ASSESSMENT REPORT

Section 75W Modification Tweed Ultima, Modification 6 (DA-456-10-2003 MOD 6)

Figure 8: Preferred ground level plan with new screening and retail tenancy.

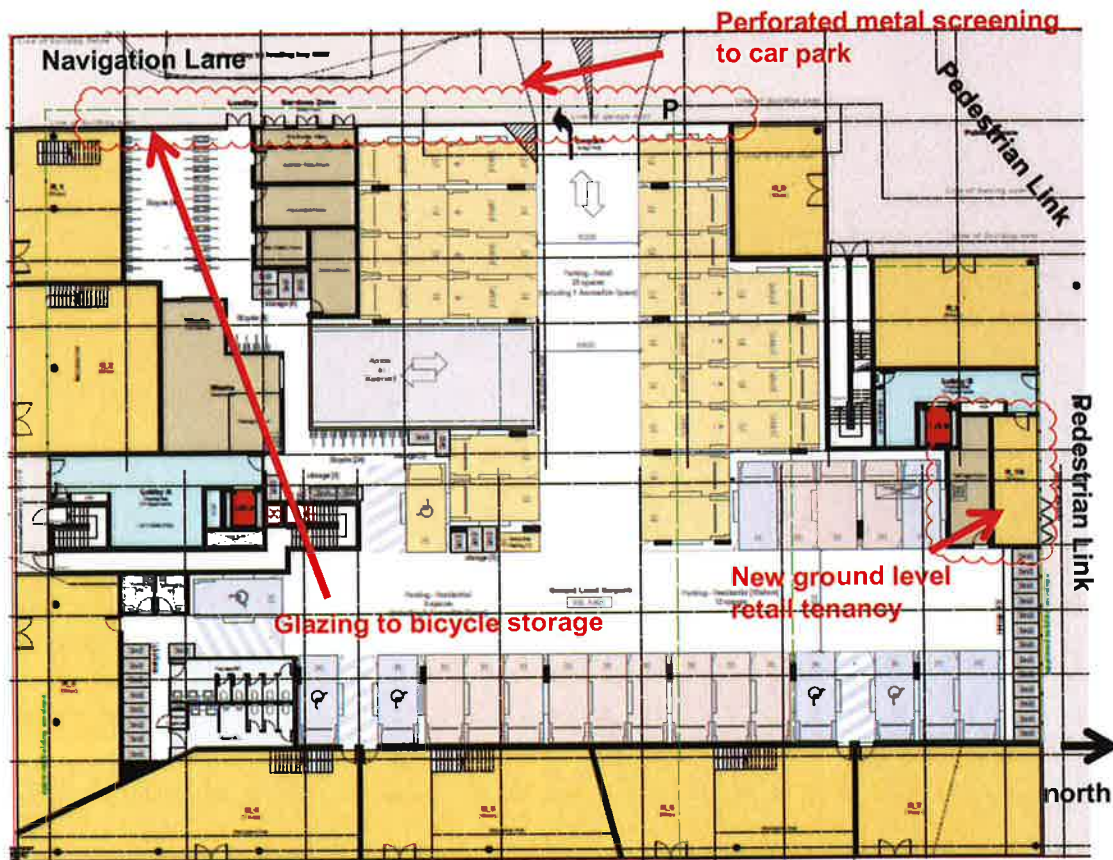
The 10 remaining retail tenancies facing Bay and Wharf Streets activate those streets. However, the ground level redesign reduces activation to the north and west frontages due to a long blank wall facing Navigation Lane and the pedestrian link, which provides less than 30% of active frontage.

The proponent's RTS provided an additional ground level retail tenancy to the north elevation; glazing to the bicycle storage area; and perforated metal screening to the ground level interface with the Navigation Lane (see **Figures 8 and 9**).

The department considers that the additional retail tenancy, perforated screening and glazing will improve activation and passive surveillance of Navigation Lane. For the remaining 12m blank wall facing the pedestrian link (see **Figure 10**), the department has recommended continuation of the perforated screening to improve passive surveillance from the car park. An example of perforated screen is shown in **Figure 11**.

By way of improving the urban design attributes of the proposed ground level, the proposal includes an additional retail tenancy suitable for a coffee or juice stop facing the pedestrian link, and glass and perforated metal walls, which reveal the interior of the building to provide age, visual interest and encouraging passive surveillance. Overall, with the inclusion of the recommended condition for an additional perforated screen along the 12 metres of blank wall along the pedestrian link, the department is satisfied that the proposed ground level redesign is a satisfactory urban design outcome.

Figure 12: Potential for pedestrian/vehicular conflicts on Navigation Lane.

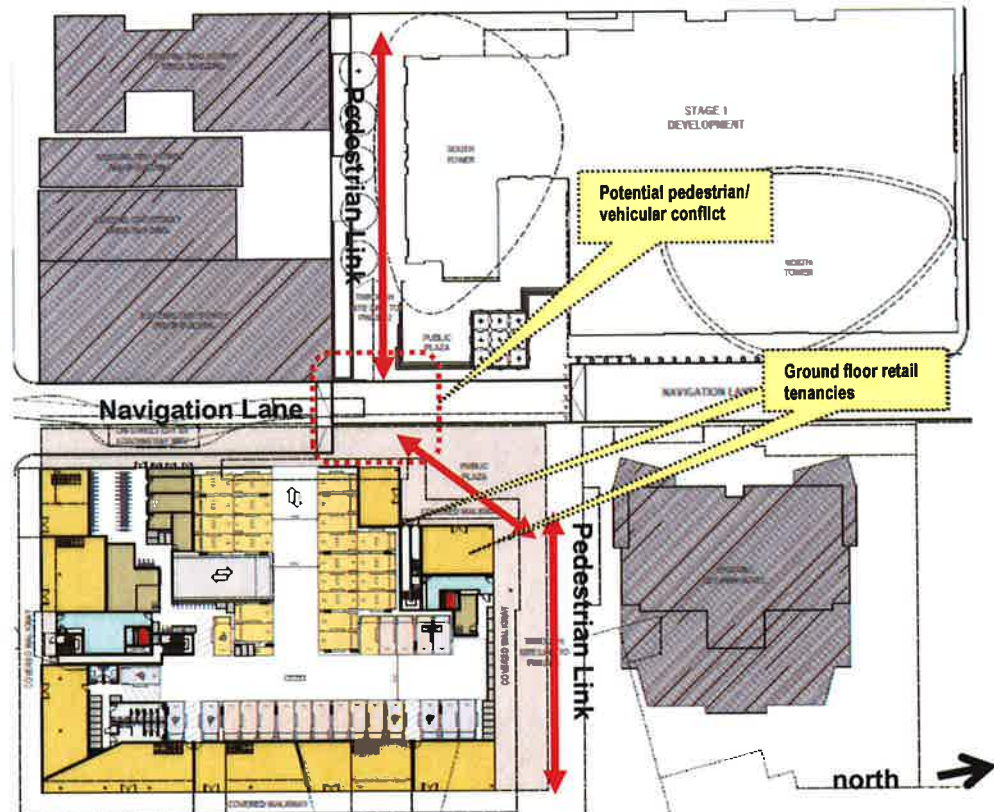
Navigation Lane will become the main vehicular access to the development due to the proposed deletion of the basement level 1 connection with the Stage 1 car park. This will generate an additional 78 vehicular trips per hour on Navigation Lane and has the potential to increase vehicular conflicts with pedestrians on the pedestrian link (see **Figure 12**).

Figure 13: Proposed vehicular access with 'left out only' exit and 'no right turn' signage at Navigation Lane.

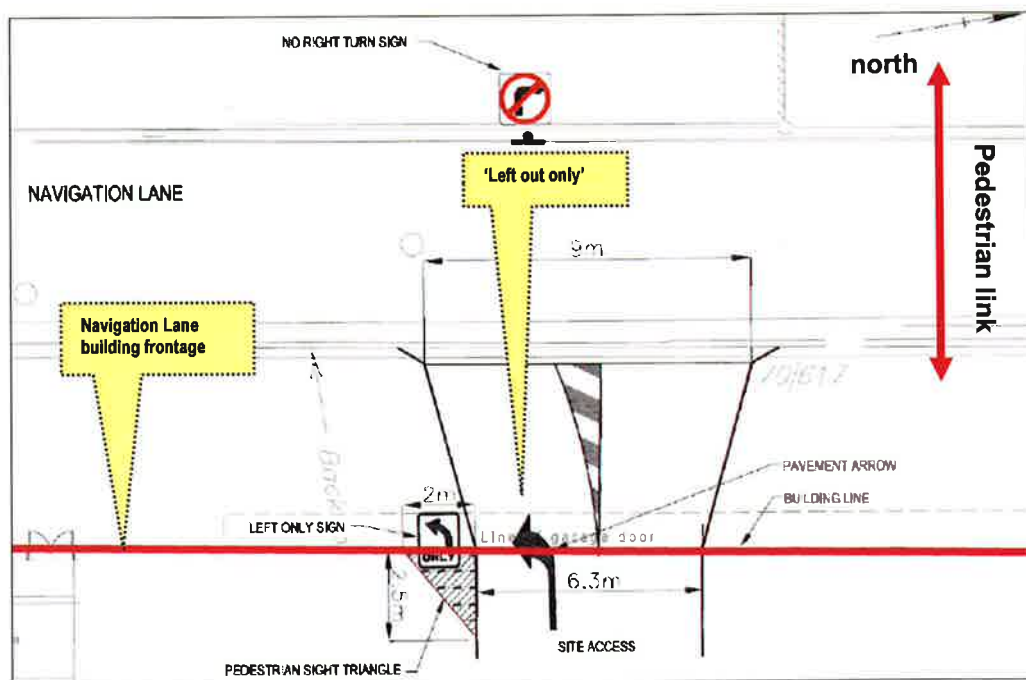
The RTS amended the vehicular access by introducing painted median to restrict vehicles leaving the site to a 'left out' exit. The department considers that the proposed driveway treatment combined with 'no right turn' signage will adequately reduce vehicle-pedestrian conflicts (refer to **Figure 13**).

The department is satisfied that the proposed traffic management measures will minimise vehicular conflicts on the pedestrian link. The recommended conditions of approval require 'no right turn' signs for vehicles exiting the site and restricting entry via Stuart Street.

Figure 14: Site showing north/south traffic flows along Bay Street via Navigation Lane.

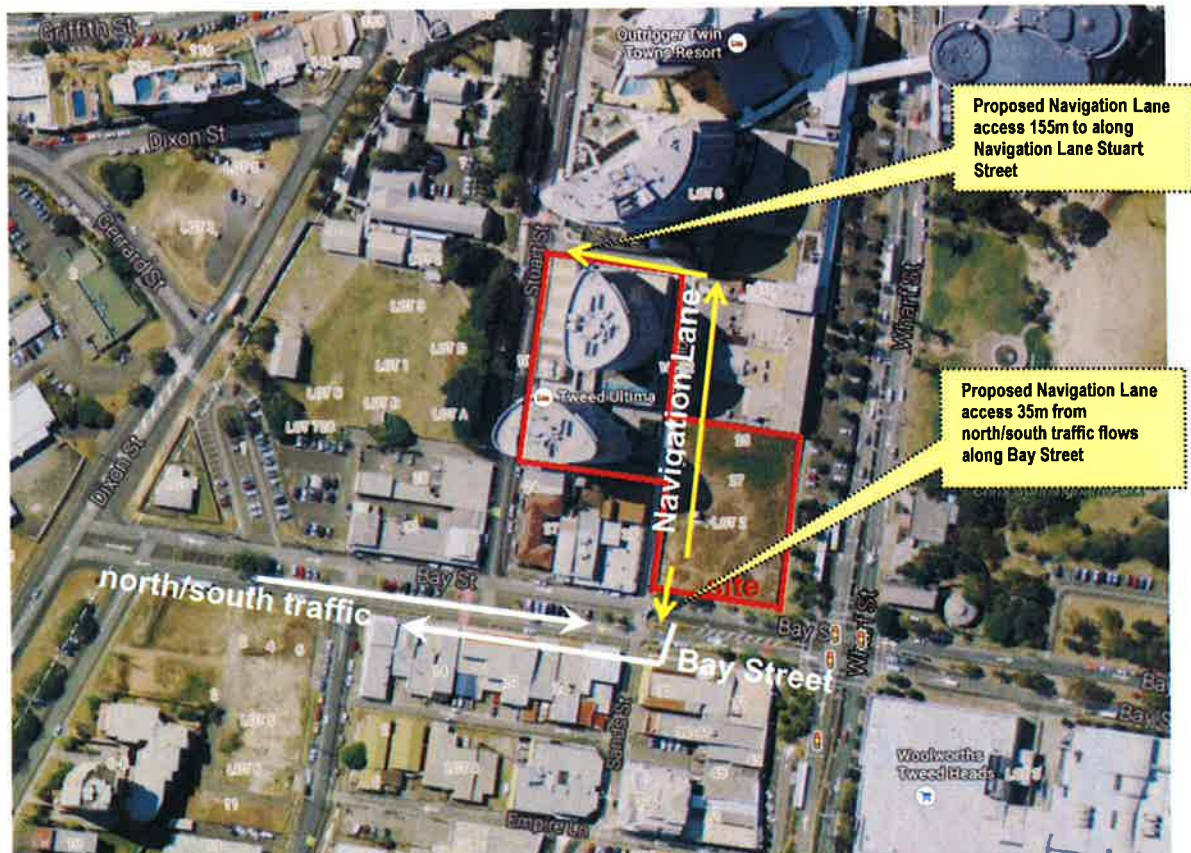
Restricting movement to left turn out means vehicles will need to travel only 35m. This compares with a distance of 155m if access to the north (to Stuart St) is unrestricted (see **Figure 14**). Bay Street via Navigation Lane is the most direct route for both northbound (Gold Coast) and southbound (South Tweed) traffic accessing the site. Council has also indicated its support for the proposed vehicular access treatment.

Figure 15: Indented service bay along Navigation Lane.

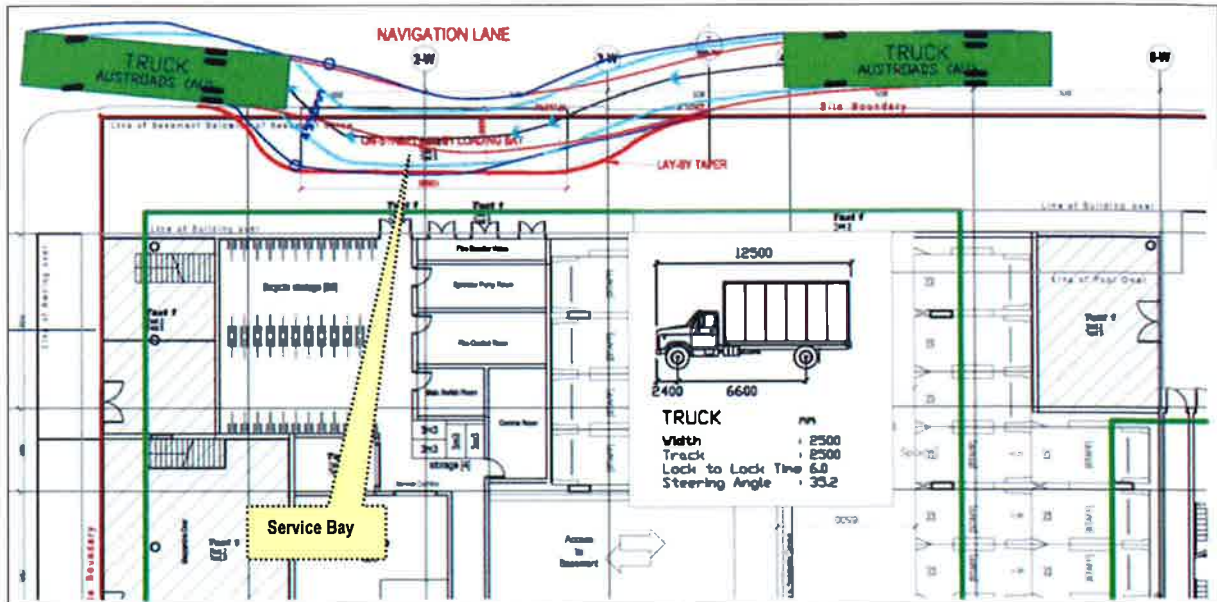
The department originally supported this 'reverse in' arrangement because of low traffic volumes in Navigation Lane. However, potential conflict now arises because of the greater number of vehicle movements along Navigation Lane, which may bank-up behind parked or reversing service vehicles.

The proponent's RTS amended the eastern ground level to include an indented service bay on the site adjoining Navigation Lane. The design of the service bay (**Figure 15**) provides:

- a 12.5m length to allow access for a garbage collection vehicle;
- road tapering for efficient service vehicle manoeuvring; and
- a 3m width to store a service vehicle clear of Navigation Lane.

The department considers a service bay is required to ensure adequate traffic flow, and reduce the incidence of blocked traffic in Navigation Lane. Council supports the proposed service bay.
